Sea Link Grid Reinforcement
Pre-Submission Engagement
Suffolk County Council Response

January 2025

Sea Link Pre-Submission Engagement
Suffolk County Council Response
Appendix B: Benhall Railway Bridge
Structural Review Report

Sea Link Pre-Submission Engagement
Suffolk County Council Response
Appendix C: Benhall Railway Bridge
Principal Inspection Report

DIAGRAM D1 – BRIDGE SOFFIT

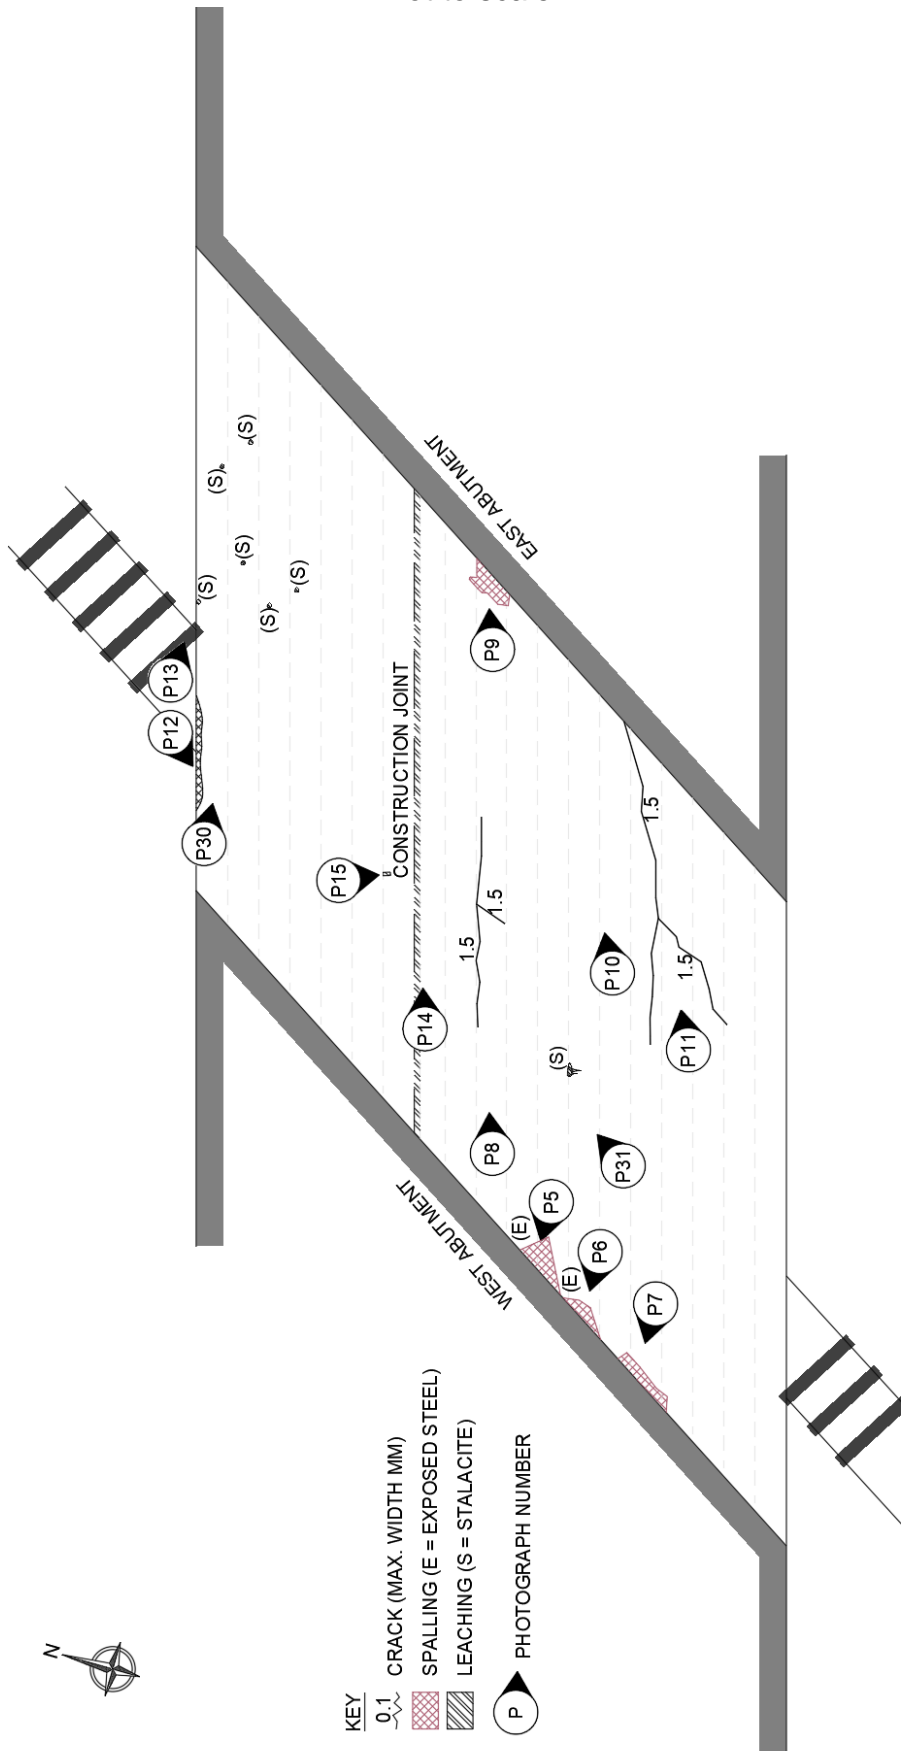
<p>The corrosion to the steel beam is likely due to seepage through the bridge expansion joint and/or failed waterproofing. The defect is at a critical location of the bridge and could lead to shear failure if the defect is not attended to.</p> <p>Previous inspections noted similar spalling defects, but the areas have increased in size and more steel is now exposed.</p> <p>The fact that the spalled concrete areas are adjacent the abutment, where significant leaching/staining is noted to the abutments (see Element 9) and the good cover to steel beams noted, suggests that the cause for this defect is attributable to failed expansion joints and water/moisture ingress.</p> <p>It is recommended that concrete repairs be carried out to the deck to ensure longevity. The steel beams should be cleaned back to sound steel and a protective paint coating applied prior to the concrete repairs. The full extent of corrosion to the steel beams is unknown and should be investigated further prior to detailed design, to ensure suitable remediation. If the extent is relatively small, then cleaning of the steel, protective coating to the steel and concrete repairs to the deck should be sufficient. If the extent is deemed to be significant and potentially affecting capacity, then a more significant deck replacement may be required.</p> <p>The extent of leaching was not measured in the previous inspection and it is a difficult defect to measure, therefore a quantitative comparison cannot be made. However, it is suspected that the defect has deteriorated due to the "fresh" nature of the deposits. The location of the leaching to the soffit and edge beams is indicative of waterproofing failure. It is recommended that the waterproofing be replaced to ensure long term durability of the structure (see Element 17).</p>

Expose the steel beam around the affected area (to clean steel), remove corrosion product and prepare to bright clean steel. Apply anti-corrosion paint to the steel, prior to concrete repair for long term durability.

DIAGRAM D2 – WEST ABUTMENT
Not to scale

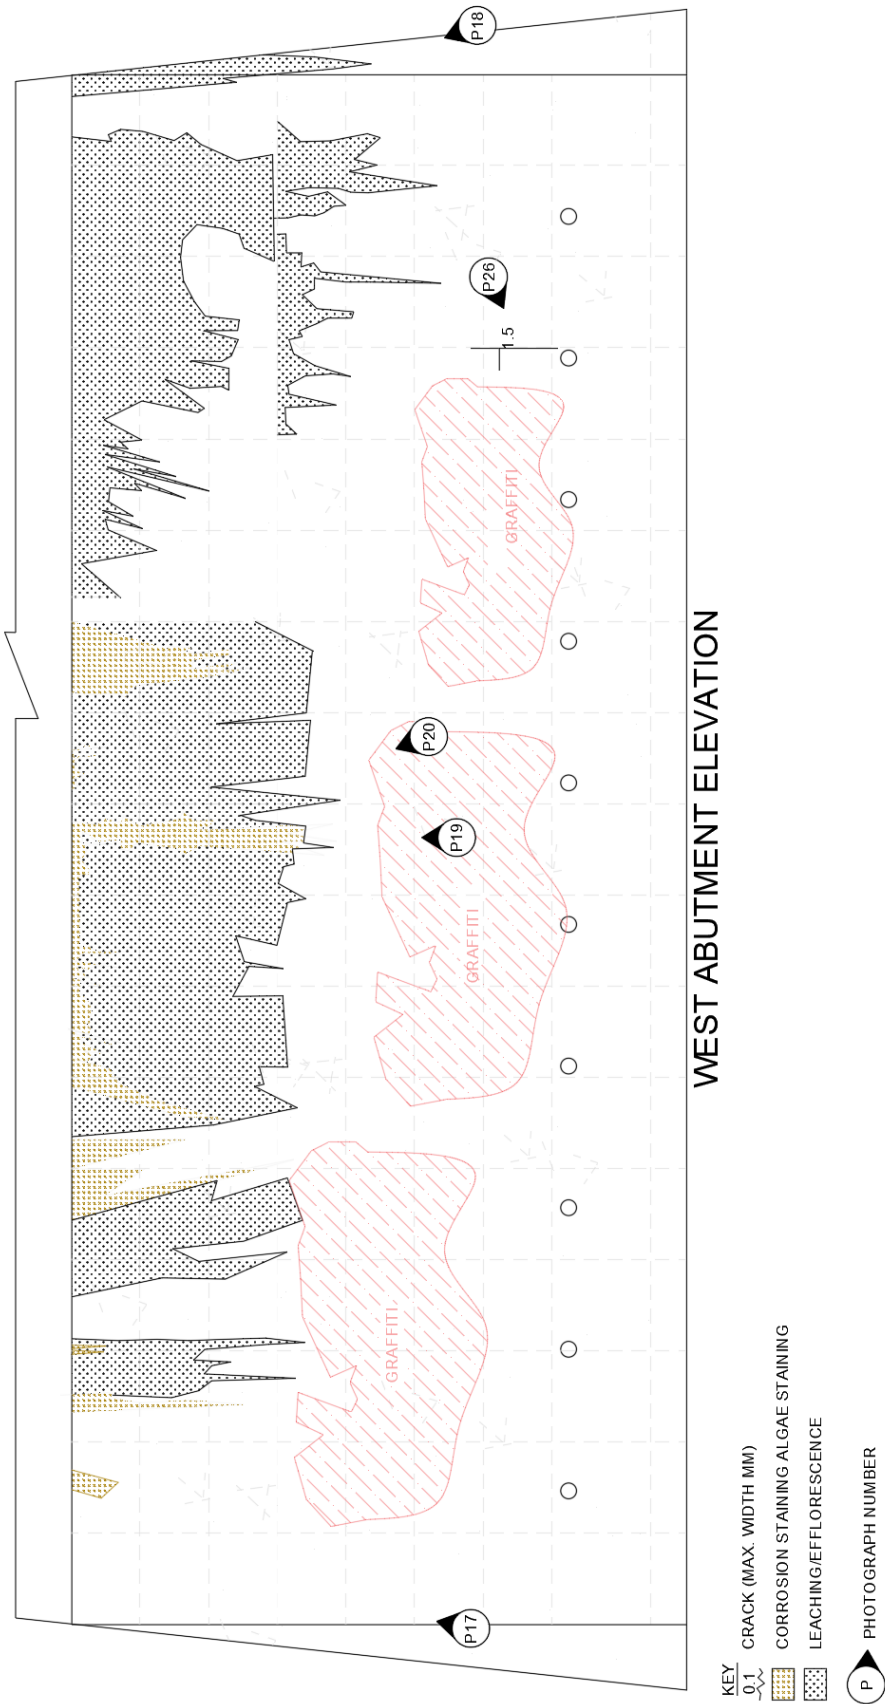
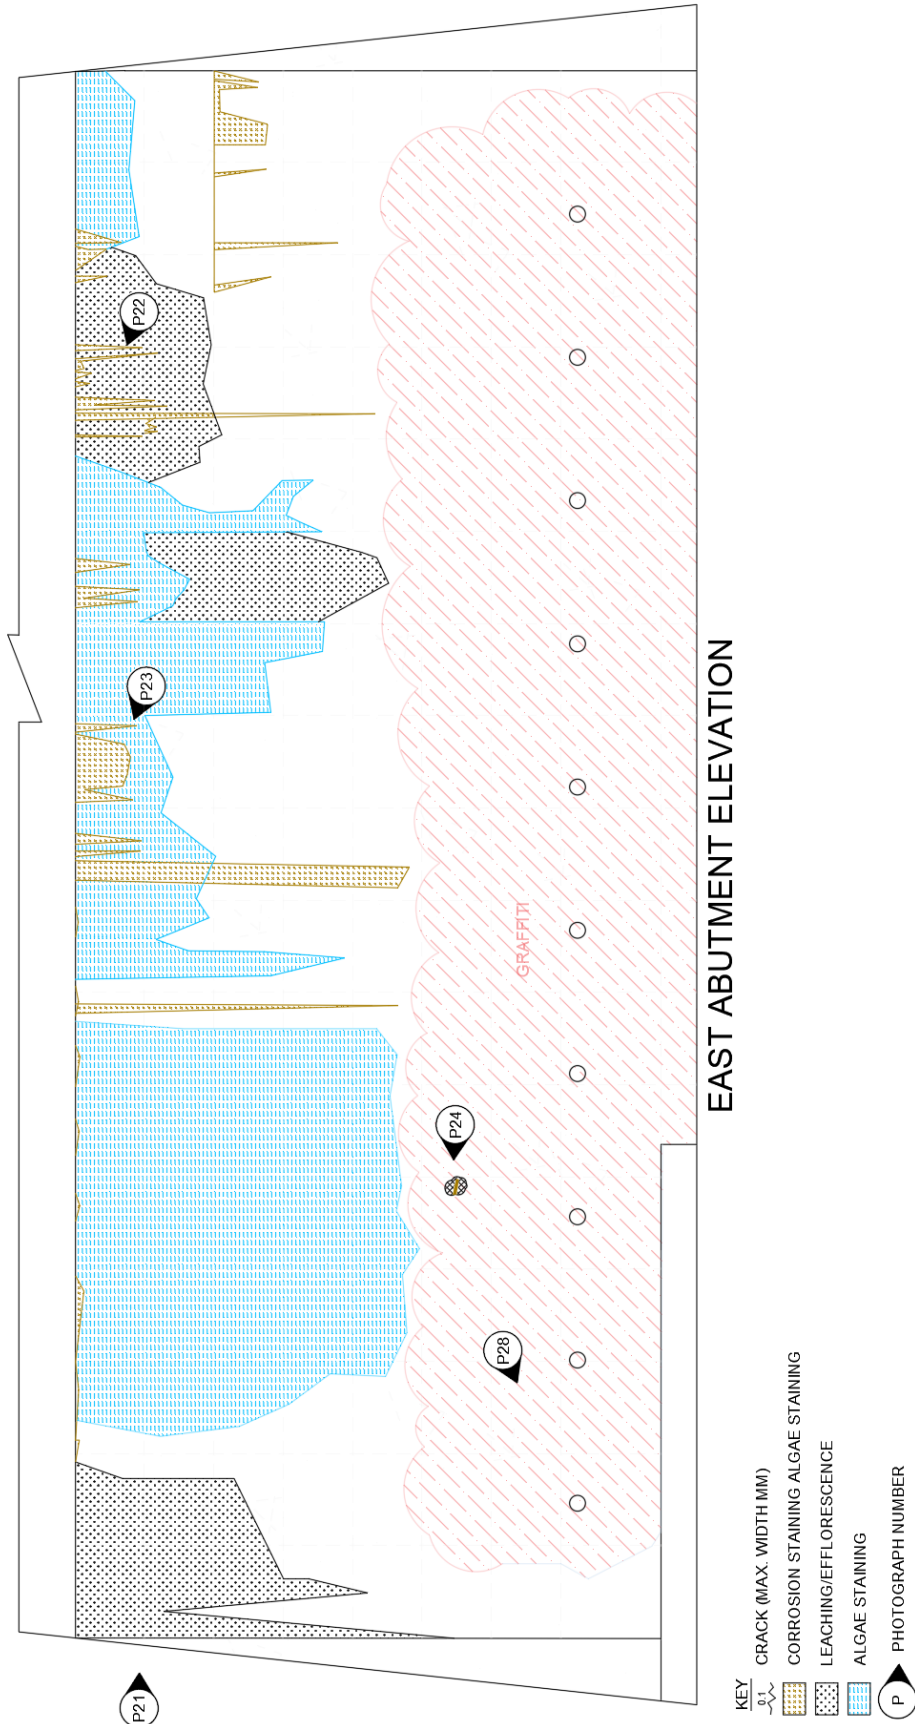
9	<p>The previous report noted leaching and staining at the top of the abutment. The staining observed on the abutments are likely due to expansion joint failure allowing water/moisture to percolate through the deck/abutment construction forms. The noticeable horizontal lines of saline deposits to the abutment face at lower levels are likely result of the steps in mass concrete construction form of the abutment and water/moisture percolating through these cold joints.</p> <p>The defect of saline leachate staining to the abutments will be having very little effect on the abutment elements themselves, since they are of mass concrete construction, but the evidence of corrosion staining suggests that the deck beams or reinforcement is corroding, and this should be addressed by replacing the expansion joints (see Element 18).</p> <p>The crack was observed in the last inspection, does not appear to have deteriorated and is minor in nature.</p> <p>The area of spalled concrete with corroding embedded object was noted during the last PI and does not appear to have changed since. This is likely to be a construction defect, as there is no reinforcement in the abutments.</p>

The previous report noted leaching and water stains at the top of the abutment. The staining observed on the abutments are likely due to expansion joint failure allowing water/moisture to percolate through the deck/abutment construction forms, over the bearing shelf and down the abutment face (it should be noted that the construction detail and presence of bearings is unclear from the as-built drawings provided. It appears that there is no movement permitted in the design of these elements). The noticeable lines of Saline deposits to the abutment face at lower levels are likely result of the steps in mass concrete construction form of the abutment and water/moisture percolating through these cold joints.

No action required.

DIAGRAM D4 – NORTH & SOUTH PARAPET
Not to Scale

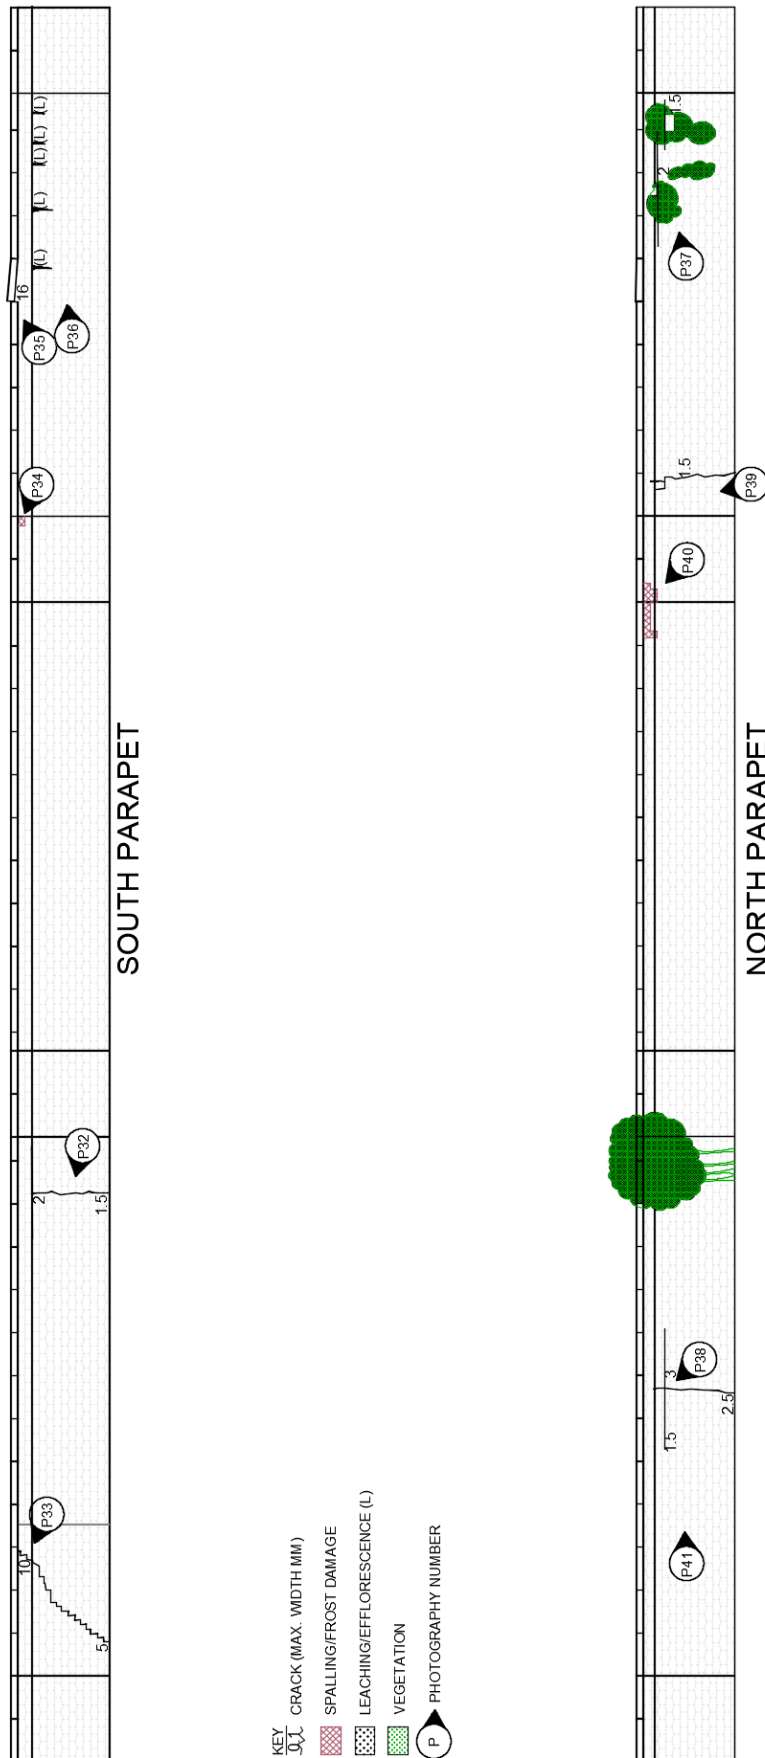
Light vegetation removal (strimming) was undertaken before the inspection, however it was not possible to remove all vegetation due to the time of year falling within the bird nesting season. Full vegetation removal is recommended prior to the next inspections.

Monitor cracks and spalled brickwork during future inspections.

Remove vegetation from parapets prior to next Principal Inspection.

DIAGRAM D5 – WINGWALLS

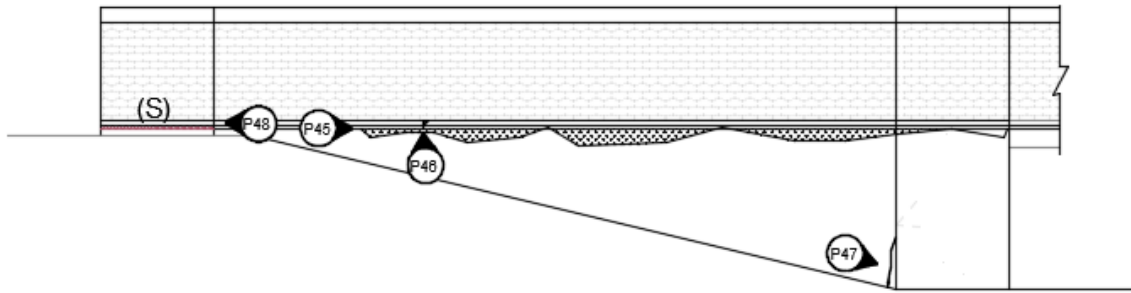
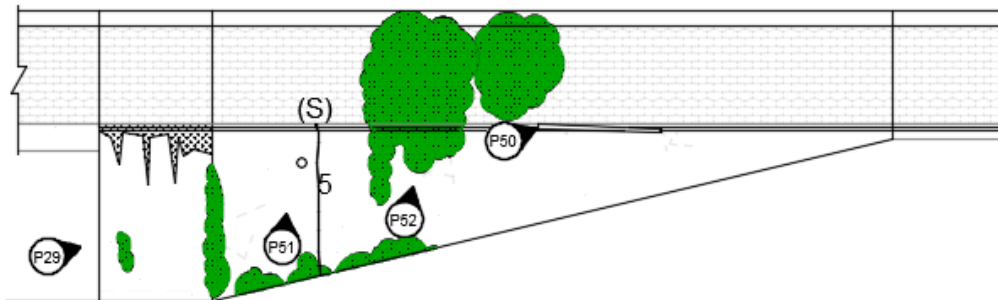
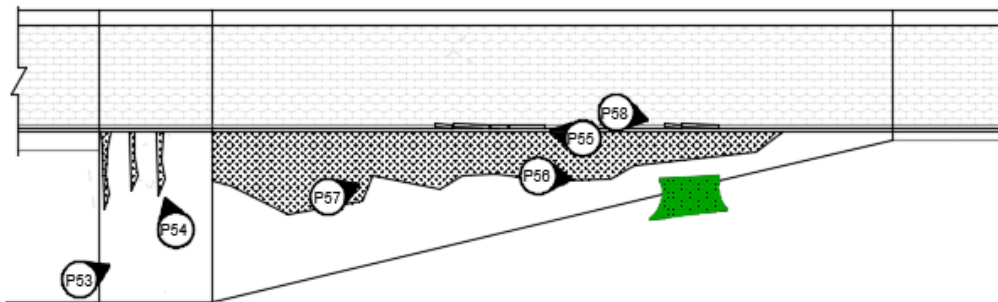
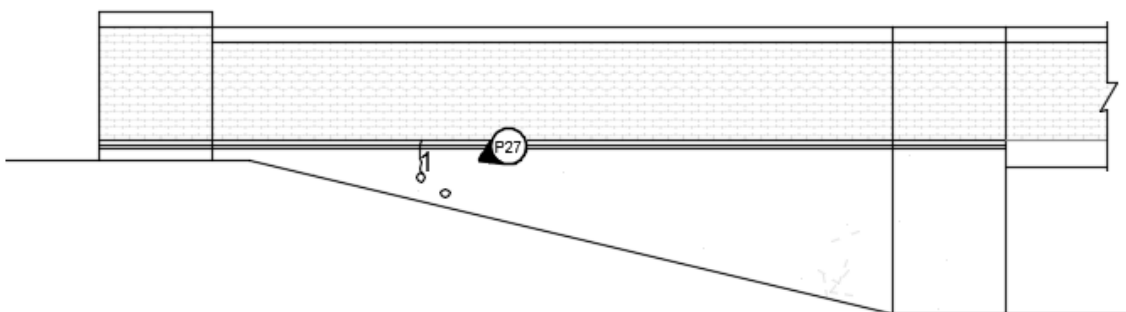
The previous inspection incorrectly numbered the wingwalls as reinforced concrete elements, they are shown as being mass concrete on the as-built drawing.

Work action:
Monitor crack widths at next inspection.
